Final Report

Boulder Creek Hydrologic Analysis

Prepared for
Colorado Department of Transportation

Response to CDOT and CWCB Review Comments

Figure B-5 - Boulder Creek 5-minute Increment SPAS Rainfall and CDWR Gage Measurements during September 2013 event

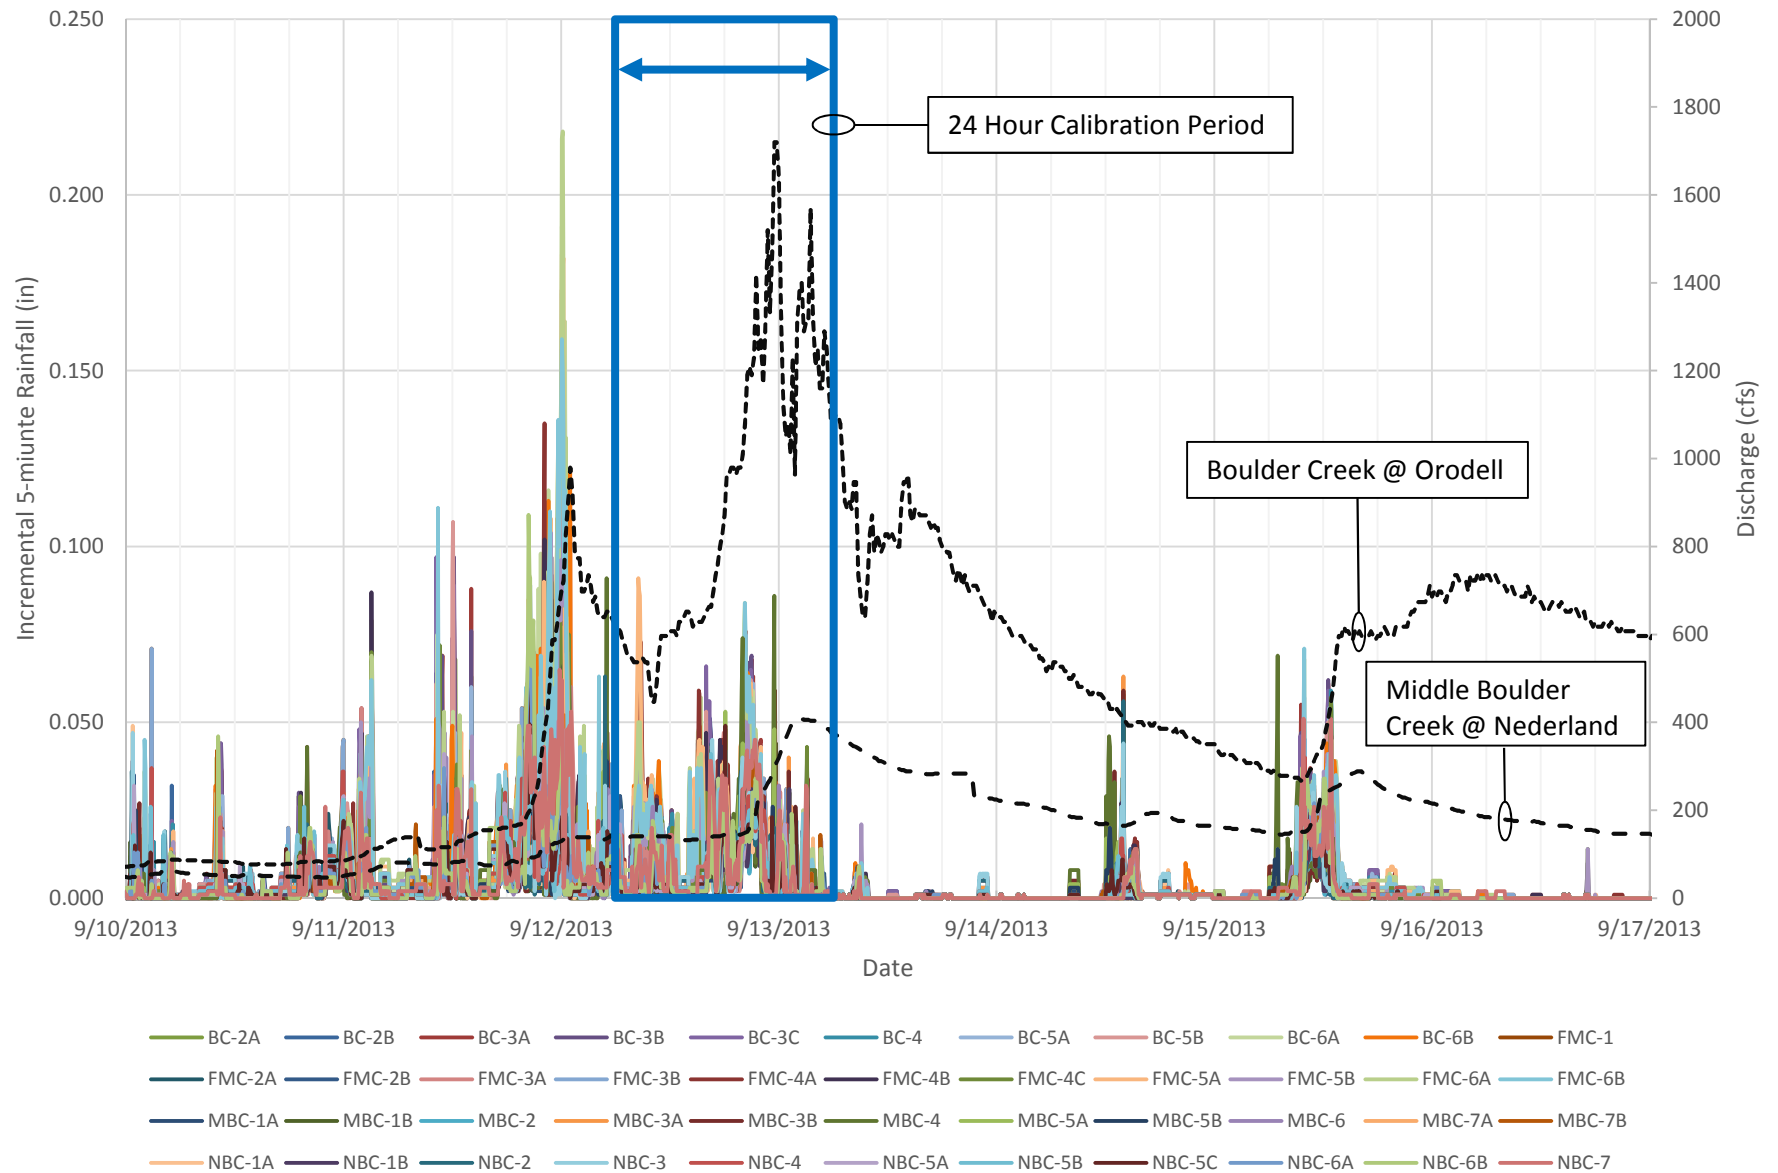
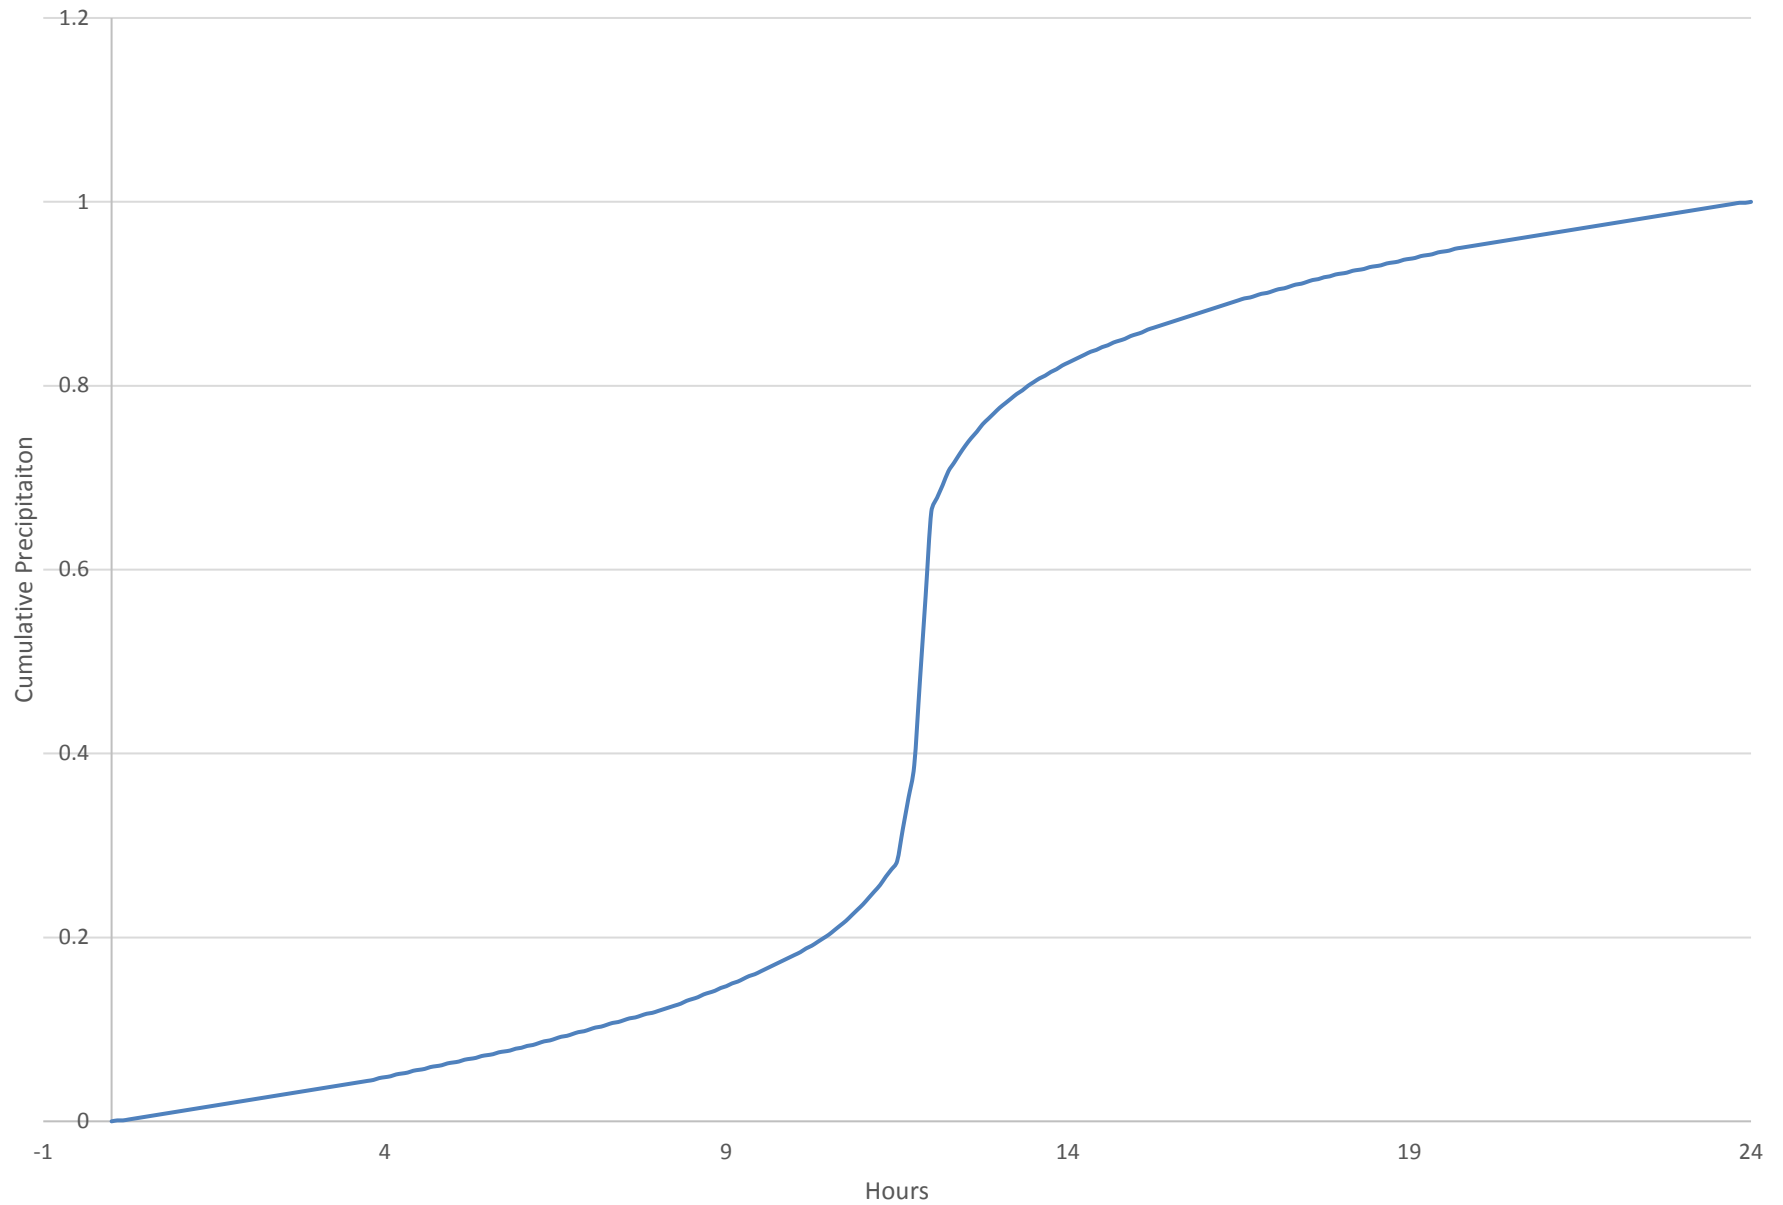
9. **Comment:** In **Section 2.4.2**, is it possible to create a graphic of the rainfall over the 7 days simultaneously illustrating the ebbs and peaks of the streamflows? That way the reader understands more clearly why the choices about 24-hours vs. 7-days were made in the development of the calibrated model.

Response: A graphic was added to the Appendix to show the rainfall event.
10. **Comment:** In **Section 2.4.5 – Rainfall Inputs subsection**, it would be helpful to have graphics of the actual rainfall distribution over the entire time and the 24-hour rainfall used in the model for the various sub-basins. The basic questions are, *“How well, in terms of rainfall input throughout the watershed, does the model represent what actually happened in September 2013?”* and *“Should we be persuaded or not?”* -
